RESPONSE TO DR RIVETT REPORT

**“Response to the Hertfordshire CC consultation on
the Groundwater Management Plan”**

Prepared for: Brett Aggregates Ltd
Client Ref: Hatfield Road Quarry

SLR Ref: 402.09887.00001
Version No:1
June 2020

DWG No. 4

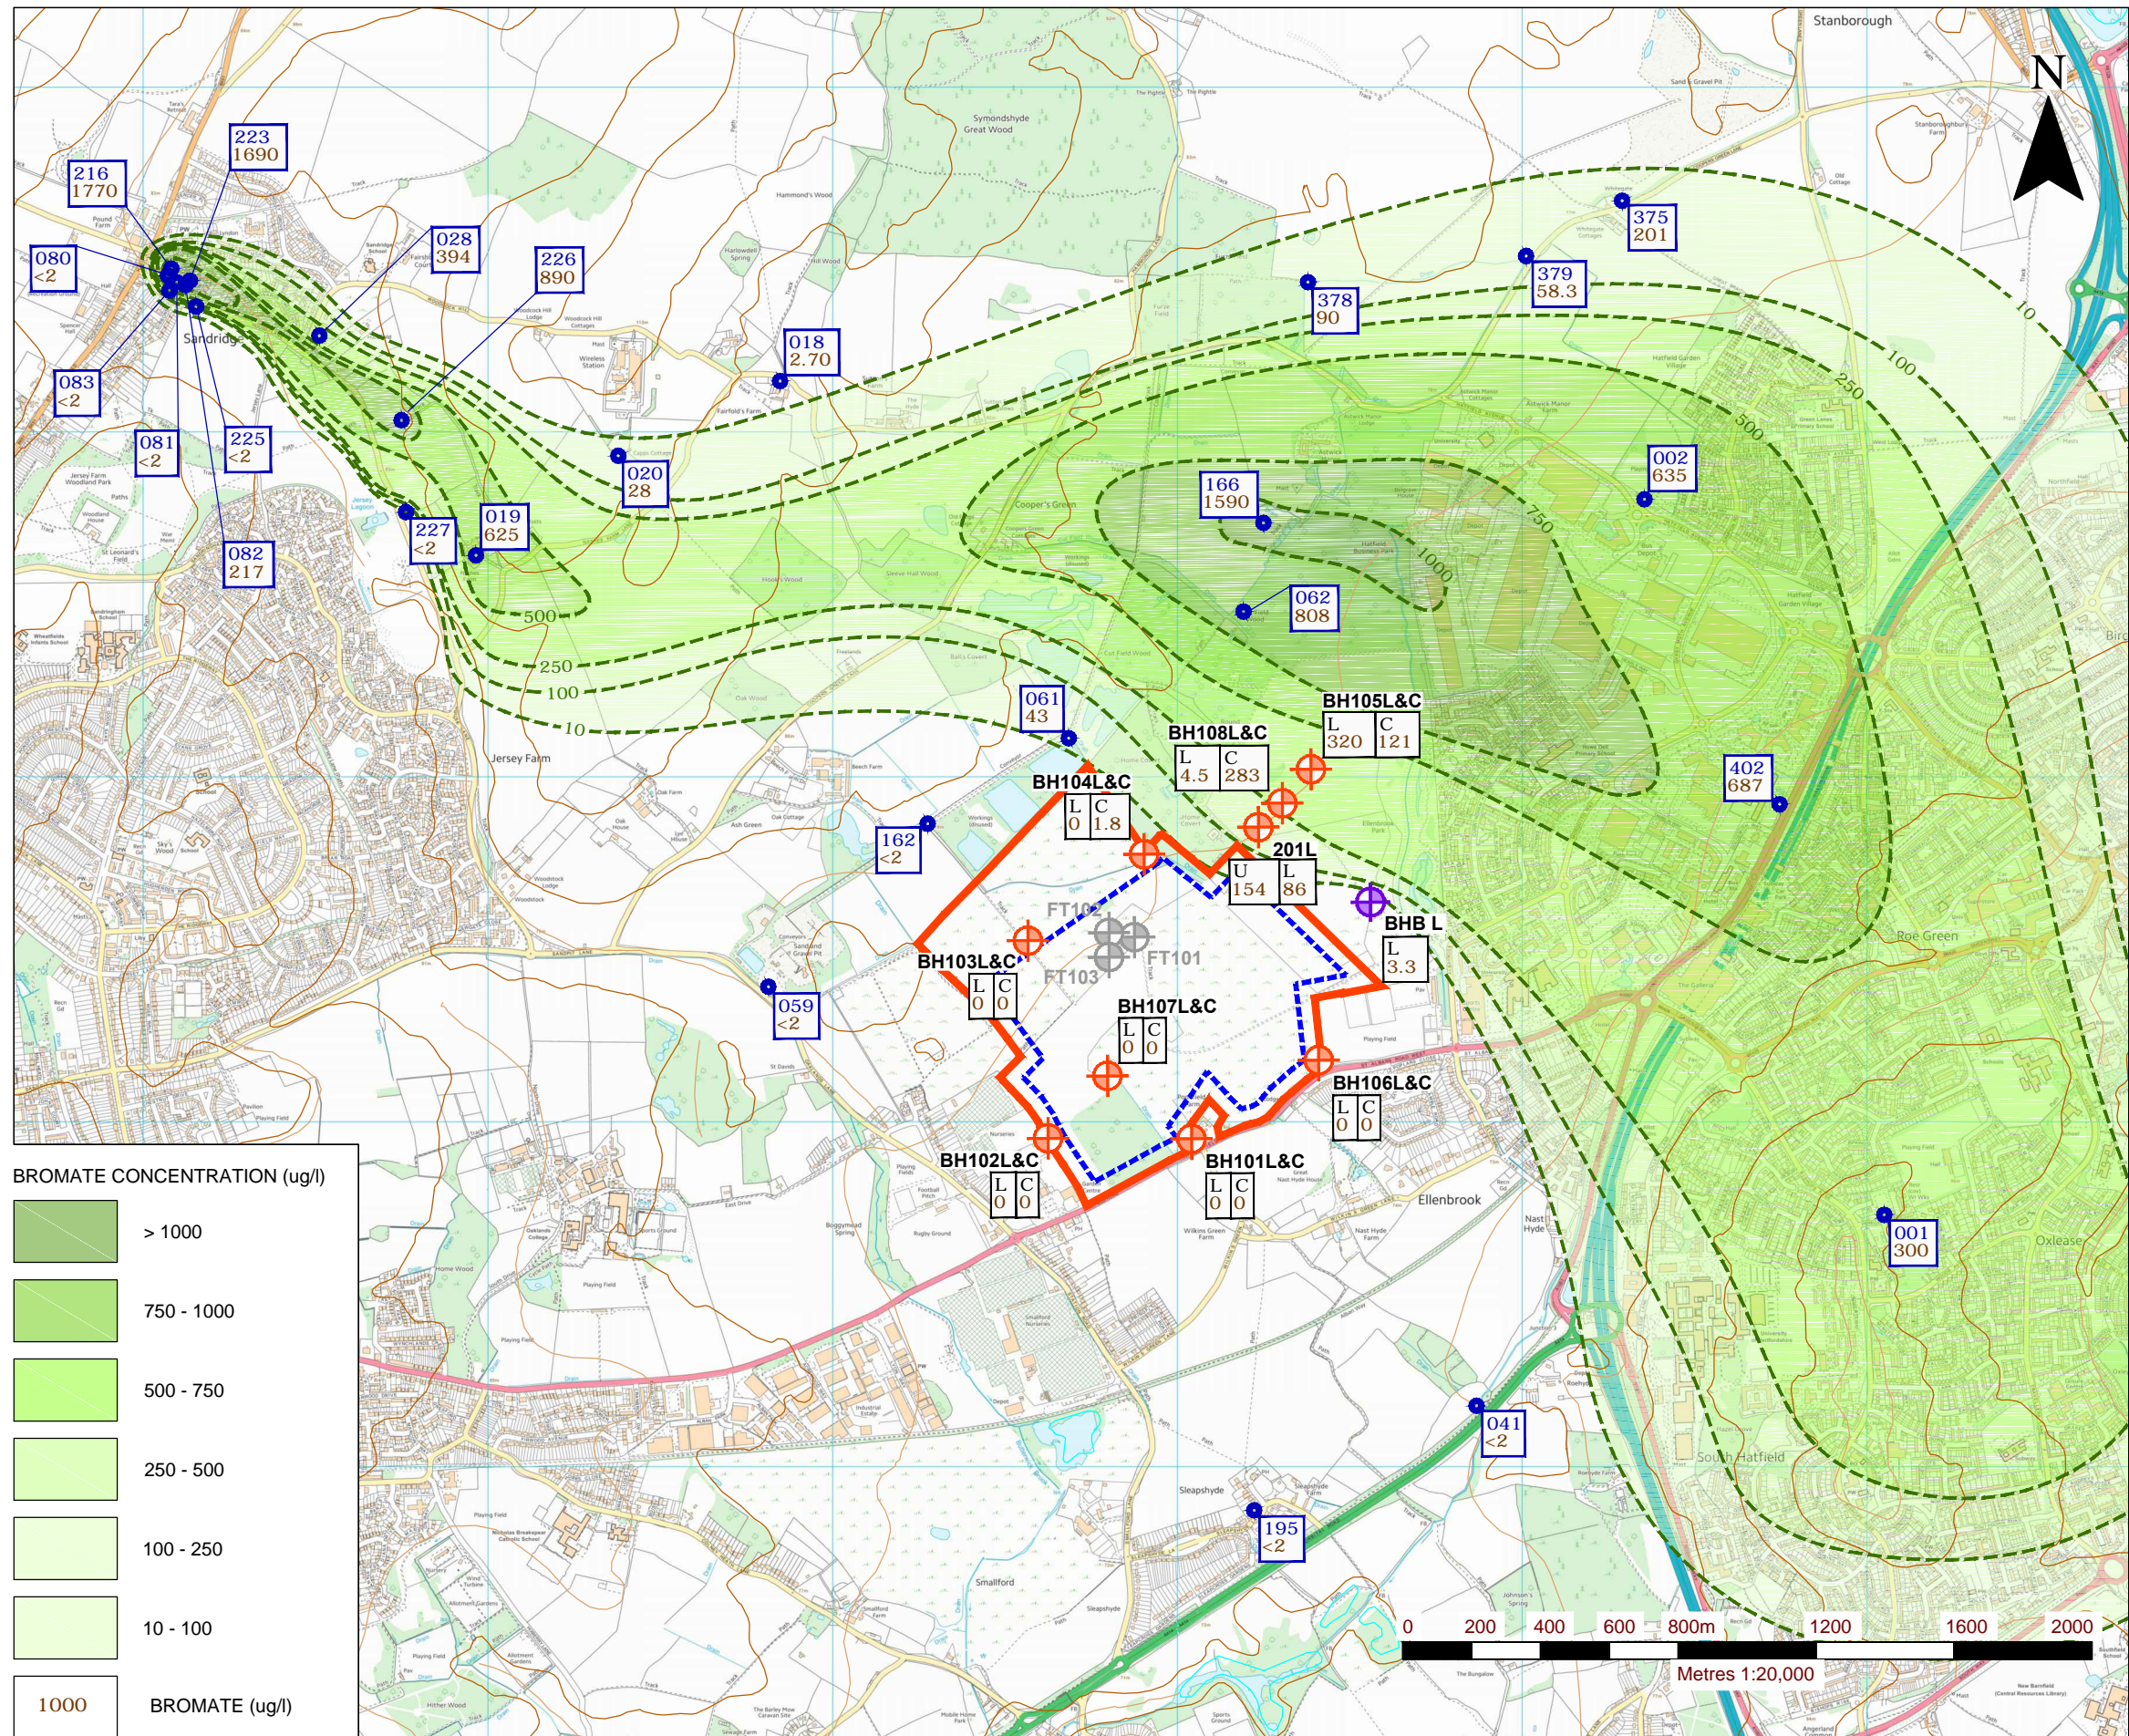
- The natural and dominant flow direction in the chalk north of the site is approximately west to east and has resulted in the plume core being located 800m north east of the site. A previously submitted regional plume drawing¹ prepared on behalf of the Applicant has not been referenced by Dr Rivett but illustrates a distinct dogleg in the plume north west of CEMEX resulting in the core of the chalk plume being where described. Although pumping groundwater from BR is designed to overcome this flow direction, the plume will always be dominated by this eastward natural flow line.

For shielding to occur the chalk plume and the overlying mineral need to be present and the piezometric surface must be within the overlying mineral. Dr Rivett has recognised this but has not explained or illustrated where this might occur. The LMH is, in fact, discontinuous to the north of the site for a combination of reasons – the chalk surface rises, minerals are absent through non-deposition or previous mineral extraction operations, and in places the mineral may simply be unsaturated. A previously submitted drawing² prepared on behalf of the Applicant has not been referenced by Dr Rivett but illustrates the absence of mineral deposits north west of the Application site.

In summary, the placement of clay fill in the excavated LMH will locally direct flow from the north west towards the east, and flow from the west will be directed to the south and then towards the south east. Fundamentally, the development will not therefore affect plume capture by BR.
